### REMARKS

In the Office Action, the drawings were objected to under 37 CFR 1.84(h)(3) and 37 CFR 1.83(a). Claims 1 and 41 were objected to. Claims 13-19, 27-33 and 43-44 were rejected under 35 USC §112, first paragraph. Claims 1, 6-7, 10-12, 21, 26-33, 35-37, 42-44 were rejected under 35 USC §112, second paragraph. Claims 1, 6-7, 11-12, 21 and 26 were rejected under 35 USC §102(b) as being anticipated by Smith. Claims 1, 6-7, 11-12, 21 and 26 were rejected under 35 USC §102(e) as being anticipated by Yang. Claims 1, 7, 10, 13, 16, 18-19, 21, 26-30, 33, 42-44 were rejected under 35 USC §102(b) as being anticipated by Gustafson. Claims 36-37 were rejected as being unpatentable over Smith and further in view of Abert. Claims 14-15, 31-32 and 35 were indicated to be allowable if rewritten to overcome the rejection under 35 USC §112, first and second paragraphs.

Fig. 1

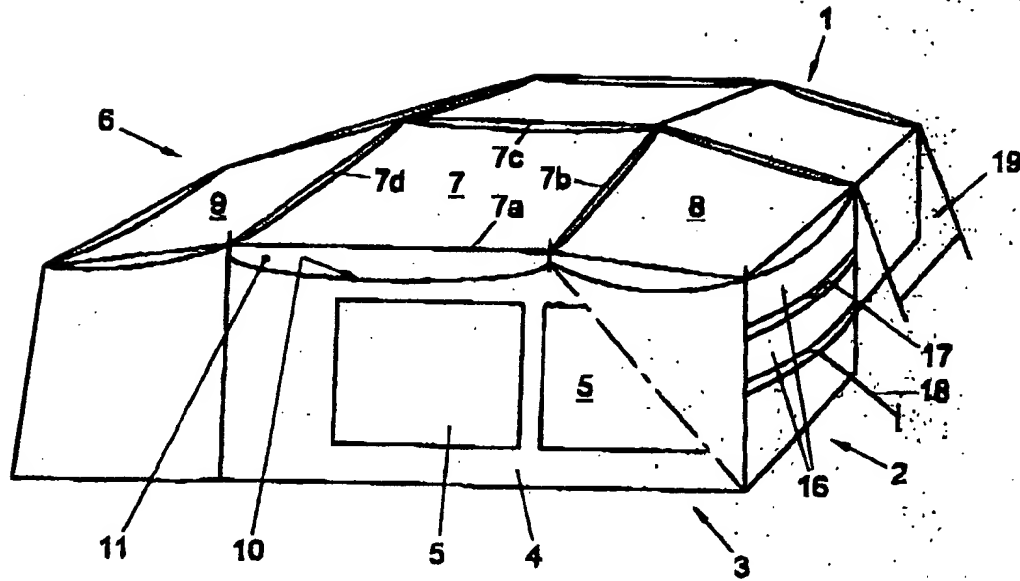
The feature of "detachable mounting a covering panel... so that it is at least partially detachable..." is shown in Fig. 1, because covering panels 16 are shown which can be pulled away from the supporting fabric of the basic panel by means of "expanders" 17 or guy ropes. Please refer to page 11, from line 11, of the specification. Further, Fig. 1 shows roof panel 7 with zippers or the like at 7a-7d along its edges, so that panel 7 is removable. Please refer to page 7, lines 4-10 of the specification. In addition, claim 1 has been amended to remove "detachably" mounting.

Still further, Fig. 1 at 19 shows a wall panel which is "stretched out". What is shown is that the covering panel 19 may be detached from the basic tent except (in this example) along its upper edge, in order to be able to swing the panel outward and fix it in that position by guy ropes or the like.

A covering panel (panel 7 in Fig. 1) is shown which is completely removable, and also for a double walled design having an outer panel (7) and an inner panel (10). The hollow appearance is

Fig. 2

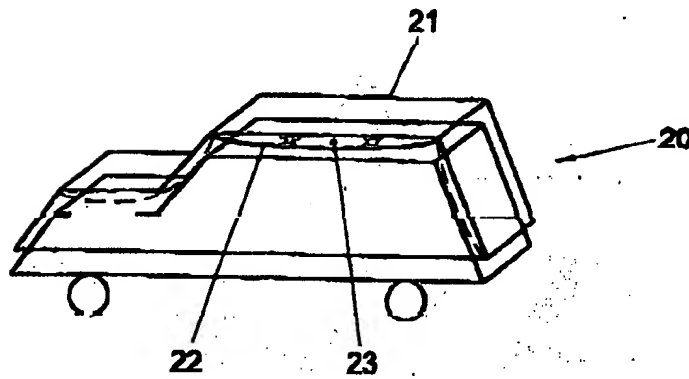
Figure 4 is not a sectional view, but as described in the Amendment filed October 28, 2003, is a detail of a spacer placed between waterproof material 21 and breathing material 22 as shown in Figure 2. A proposed correction to Fig. 2 is attached which includes two spacers in their described location.

As regards the gap, this is shown at 11 both in Fig. 1 and Fig. 3 and also in Fig. 2 in its amended form. Fig. 2 even now shows the spacers maintaining the gap.

Fig. 3

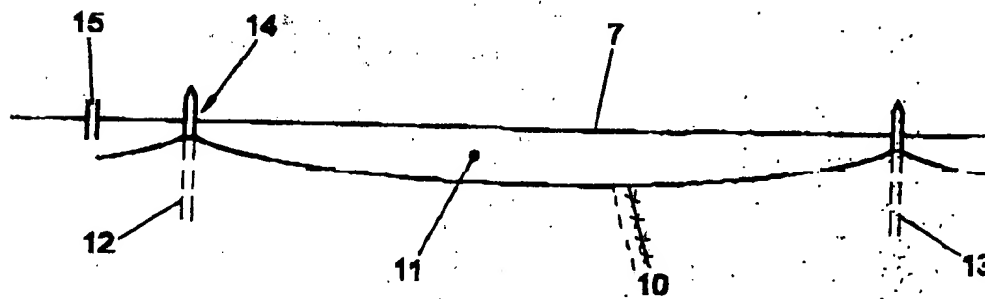
The different material feature is disclosed in the specification. Line 10 in Fig. 3 (representing inner roof panel 10) has been replaced by a dotted line to avoid this informality.
